RE: YOUR REF: MCUC 15/2014 (424543)
#1 MURPHY STREET, PORT DOUGLAS

Regarding the letter from DSC 16/07/14, we make the following comments:

LOT 2 MURPHY STREET
PORT DOUGLAS

SITE PLAN SHOWING CROSS SECTION POSITIONS

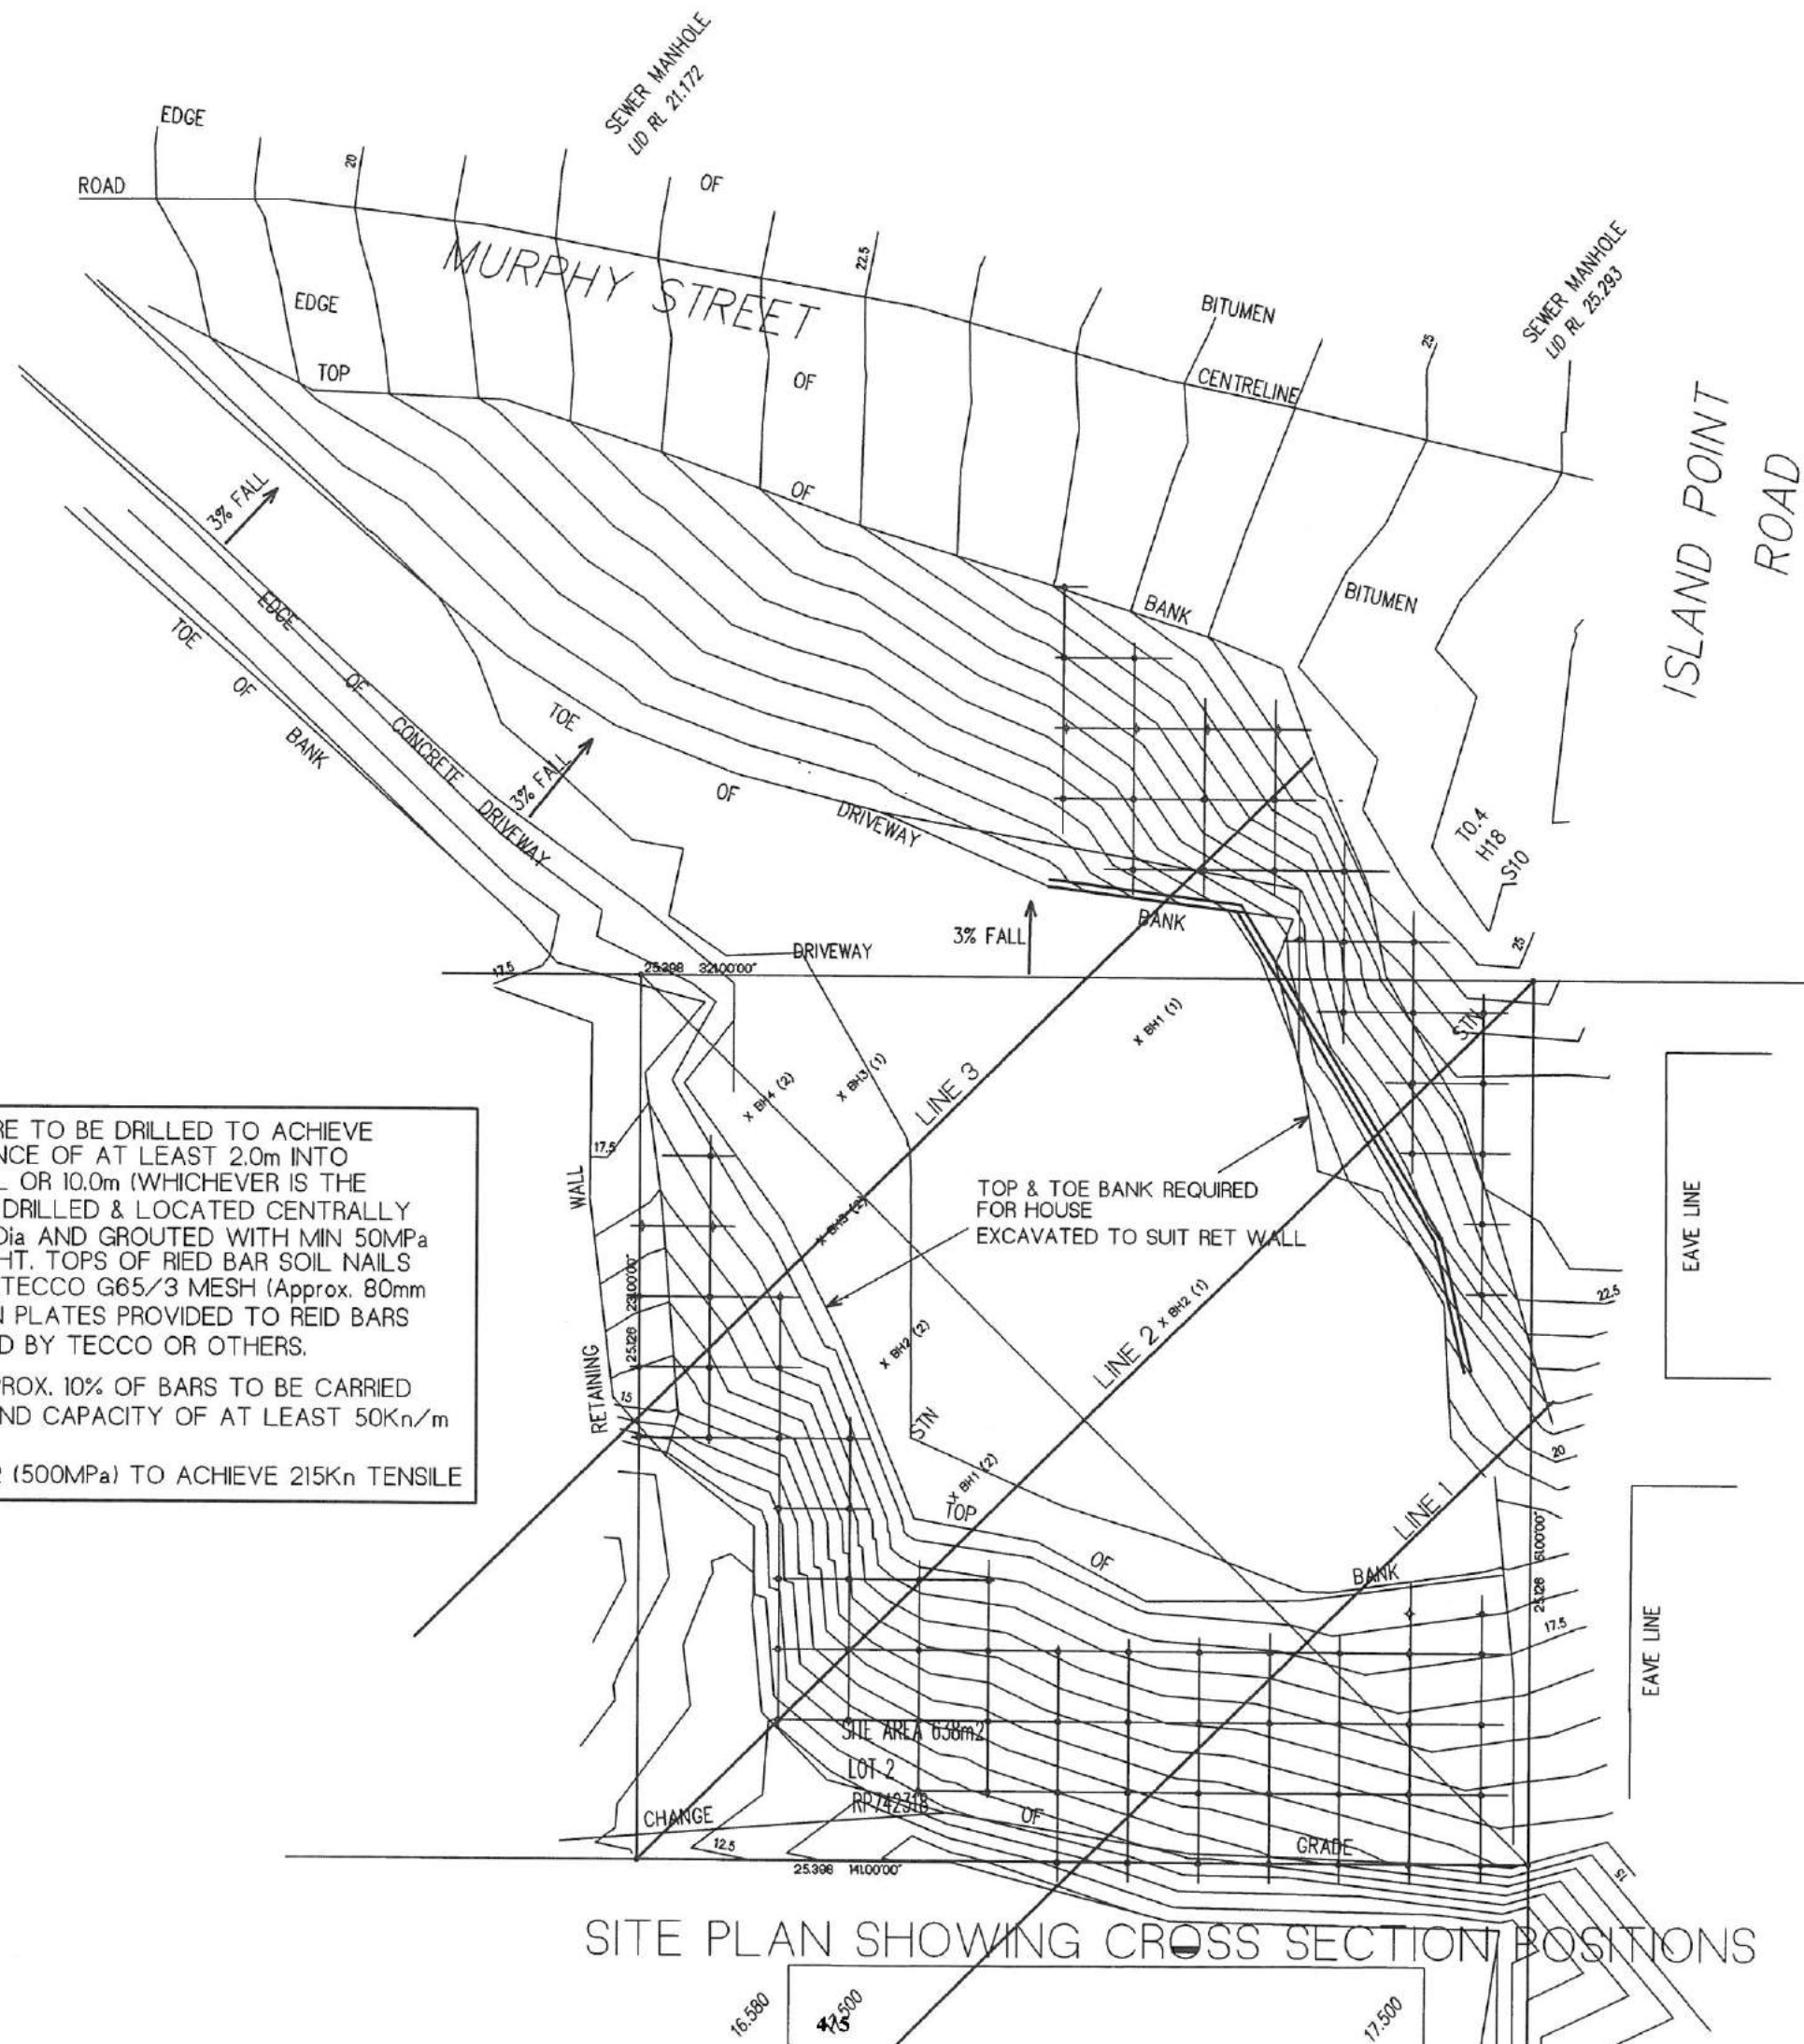
The geotechnical assessment of the property was undertaken using AGS(2007) Guidelines. Based on analysis in the previous Geotechnical reports, there appears to be no instability problems to the driveway on DSC road reserve. There also appears to be no instability problems in the past in this area. The Eastern corner of the property within DSC road reserve by analysis may require some stability amelioration by use of soil nails. Refer to ICE International drawing 14176-03 & 04.

Following analysis, the Western & Southern face of the site requires some stability amelioration by the use of soil nails at approx. 1.5m centres vertically & 2.0m horizontally overlain by TECCO G65/3 mesh. Nail lengths are to be in the order of 8-10m. Refer to ICE International drawing 14176-03 & 04.
